STATE OF CONNECTICUT
CONNECTICUT SITING COUNCIL

DOCKET NO. 436

RESPONSES OF MESSAGE CENTER MANAGEMENT AND NEW CINGULAR WIRELESS
TO CONNECTICUT SITING COUNCIL PRE-HEARING QUESTIONS, SET ONE

Attachment 4

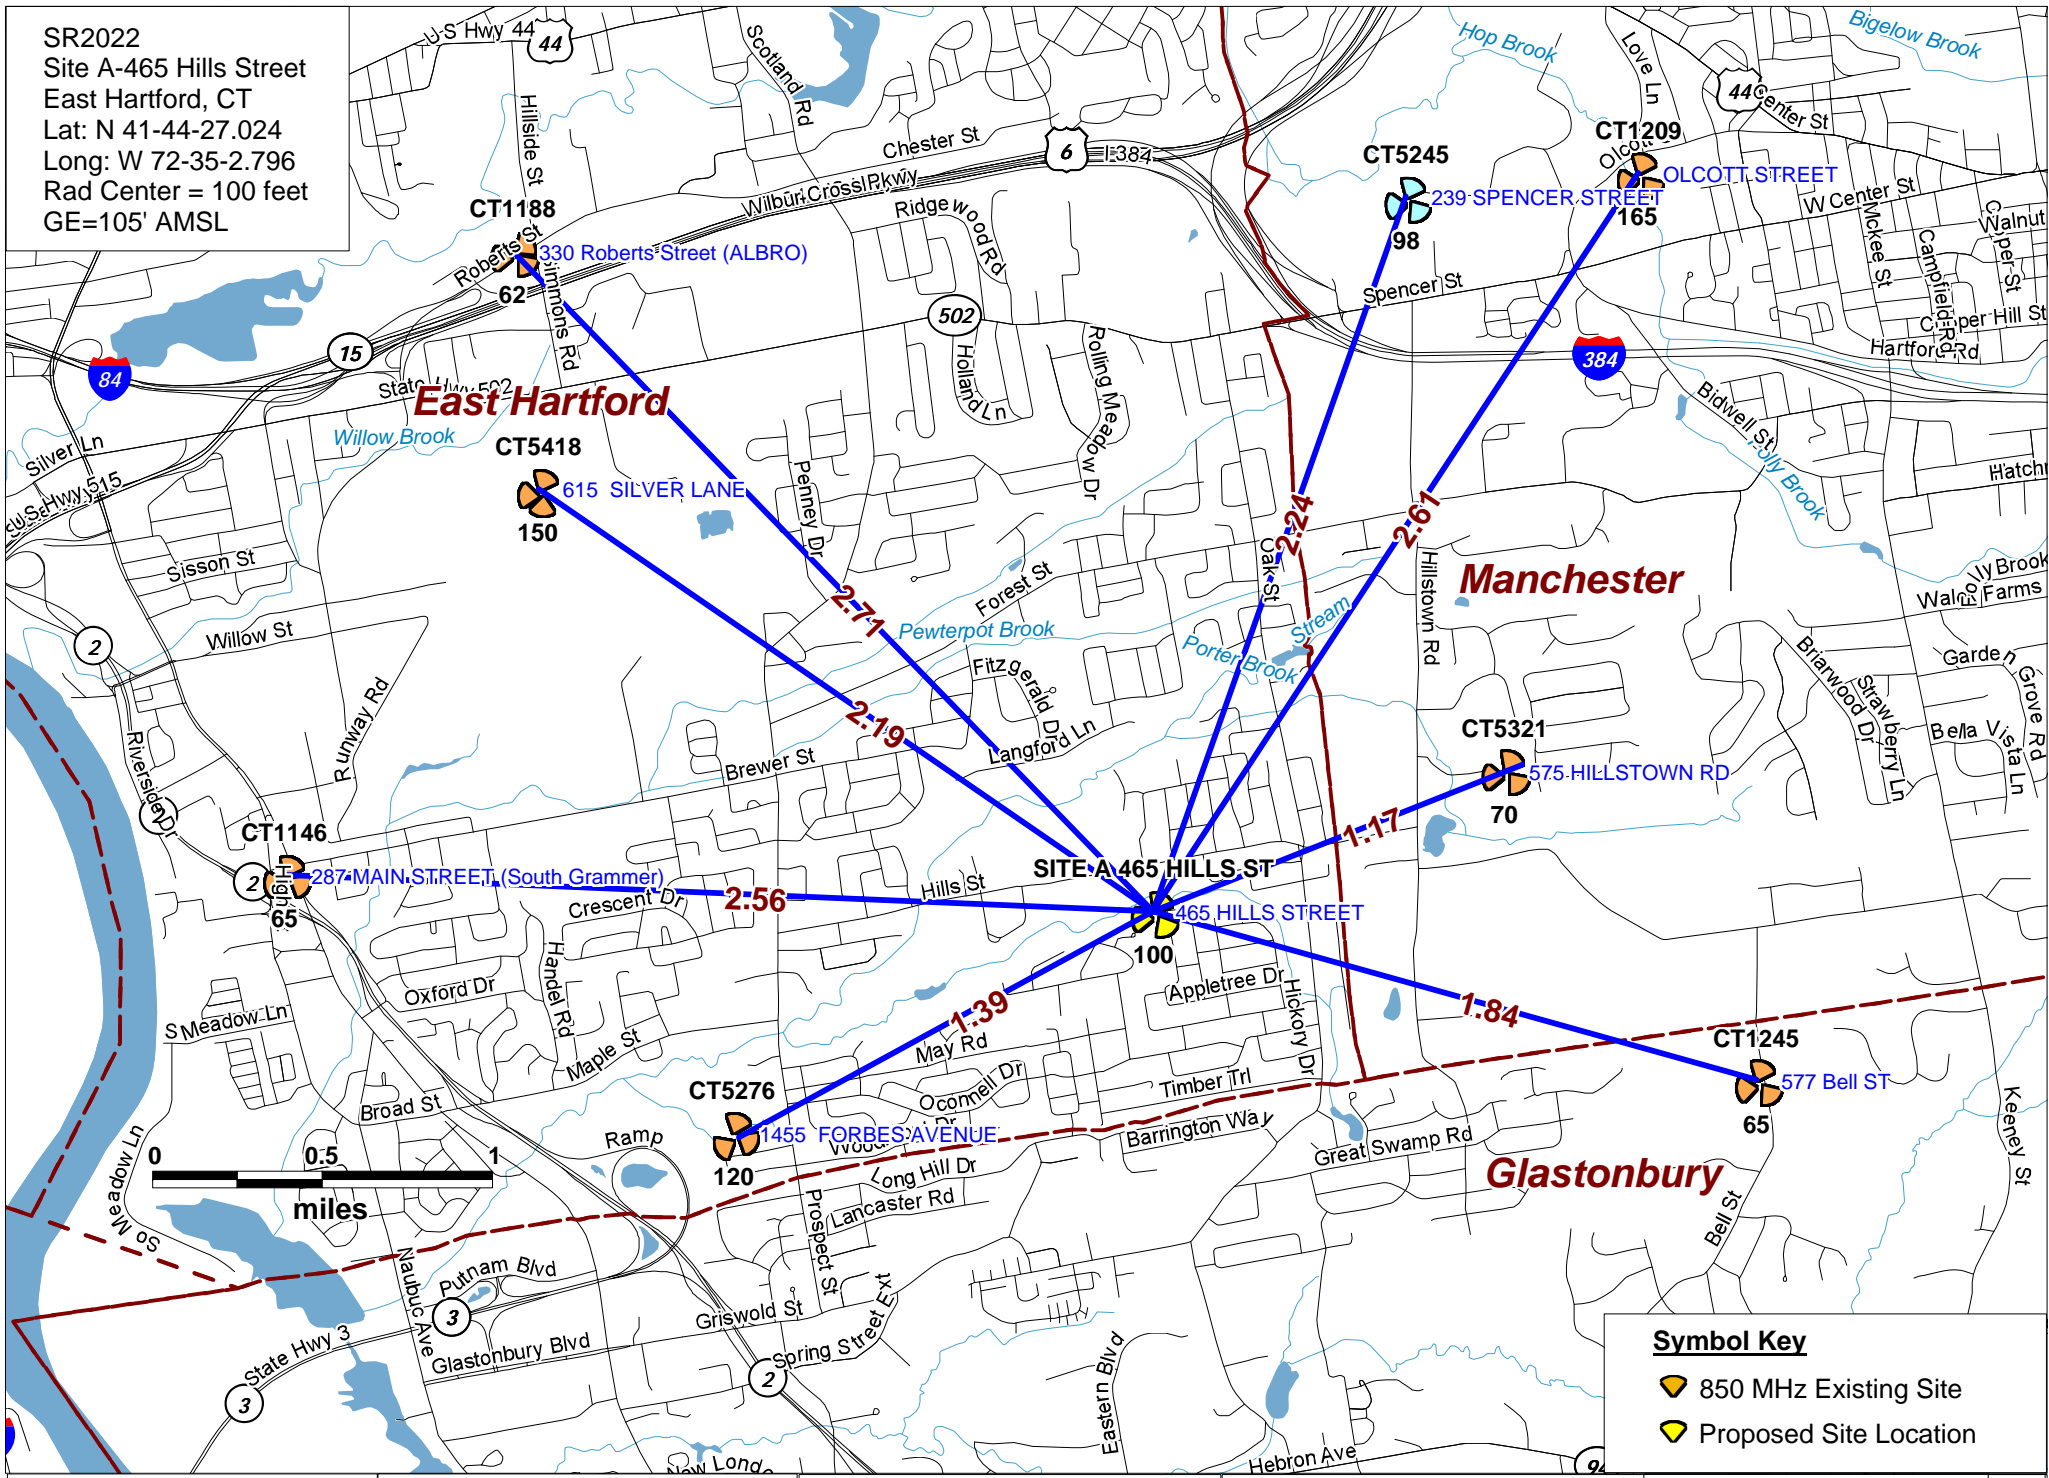
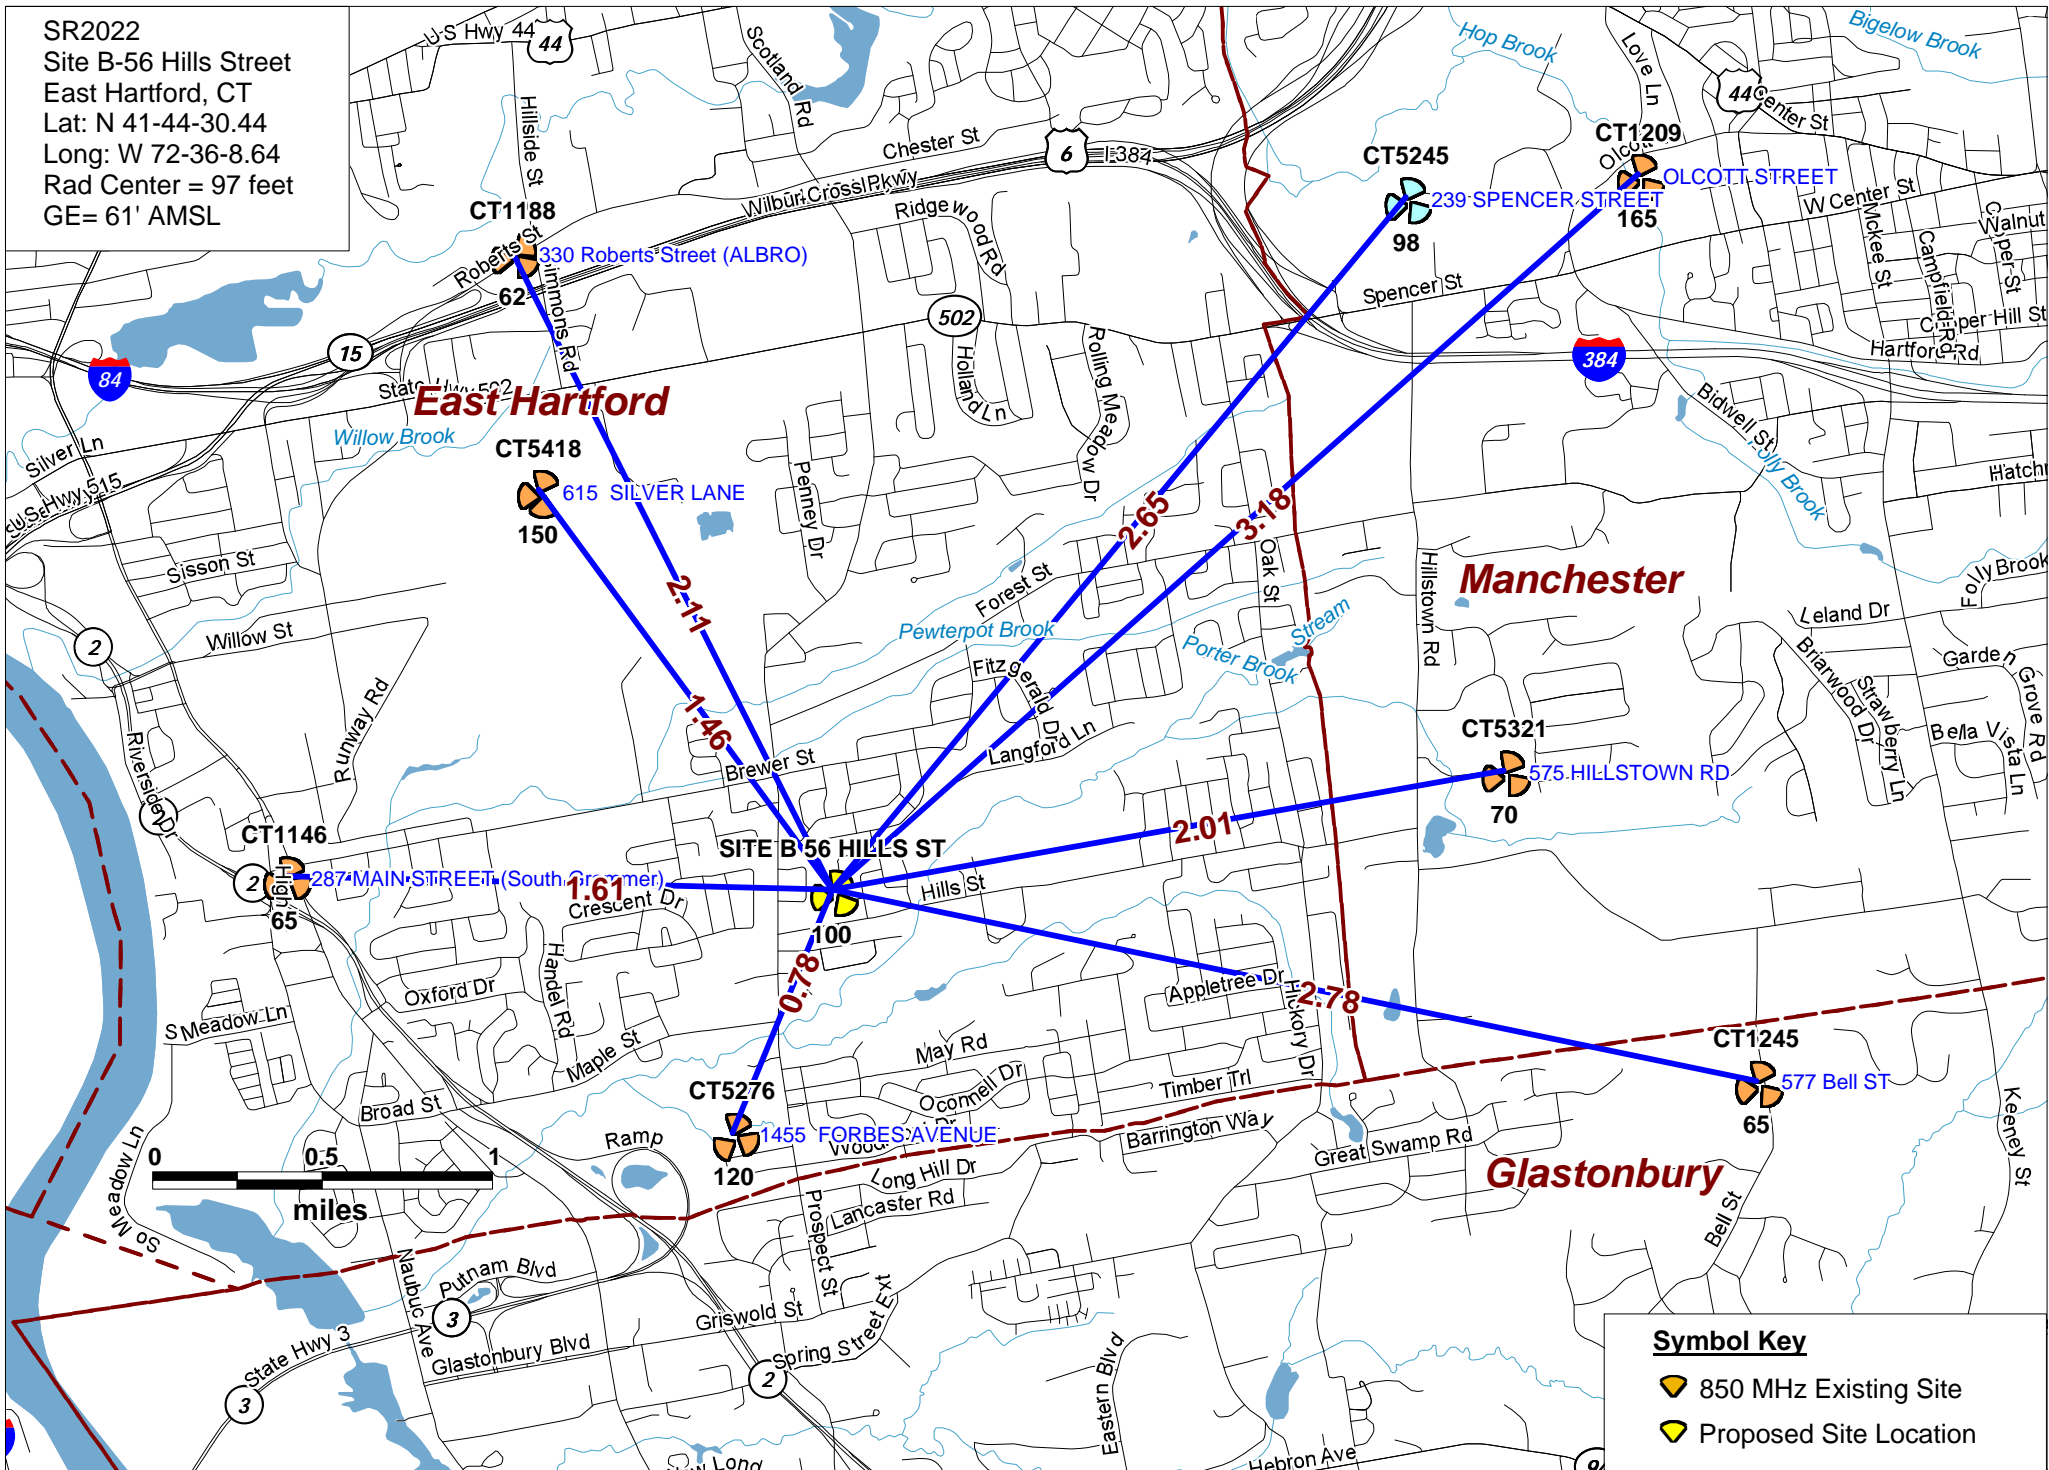
Q26. Would all of the sites listed on page 9 of the Radio Frequency Analysis Report in the Application interact with Site A?

Q43. Would all of the sites listed on page 9 of the Radio Frequency Analysis Report in the Application interact with Site B?

A26. *The Table on page 9 shows all sites in the vicinity of Site A for which interaction is possible, erring on the side of including some sites that are not particularly likely to regularly handoff to Site A. The sites most likely to handoff to Site A are depicted in Attachment 4.*

A43. *The Table on page 9 shows all sites in the vicinity of Site B, erring on the side of including some sites that are not particularly likely to handoff to Site B on a regular basis but nevertheless can do so. The sites most likely to handoff to Site B are depicted in Attachment 4.*

Attachment 6

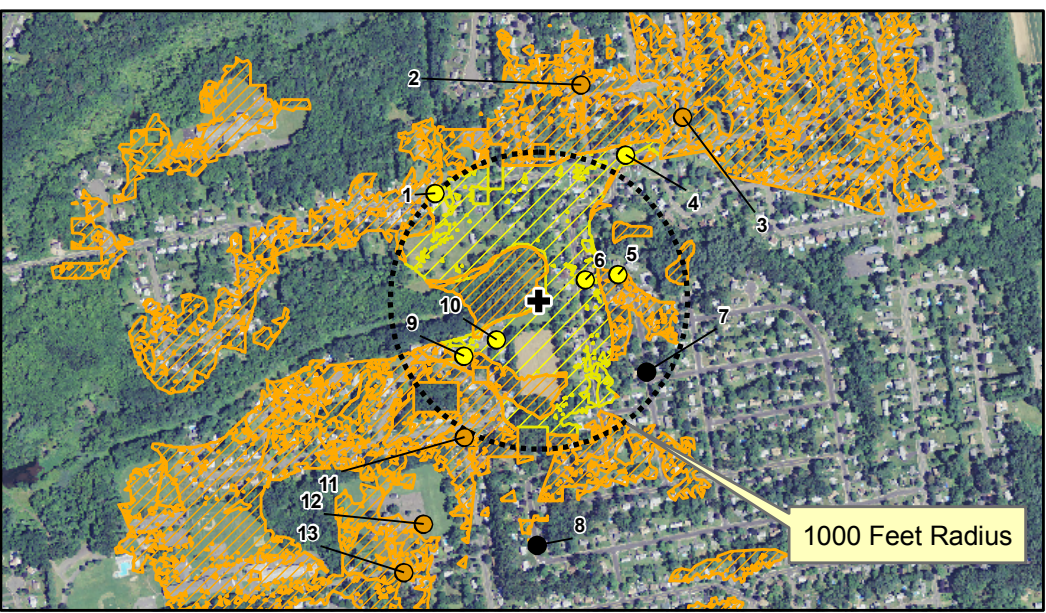
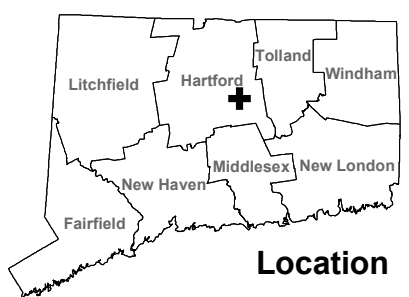
Q33. Provide a new viewshed map similar to the one in Tab 3C, but, for clarity, use the same shaded color scheme for year-round and seasonal visibility that was used for Site B.

A33. *Please see the revised viewshed map included here as Attachment 6.*
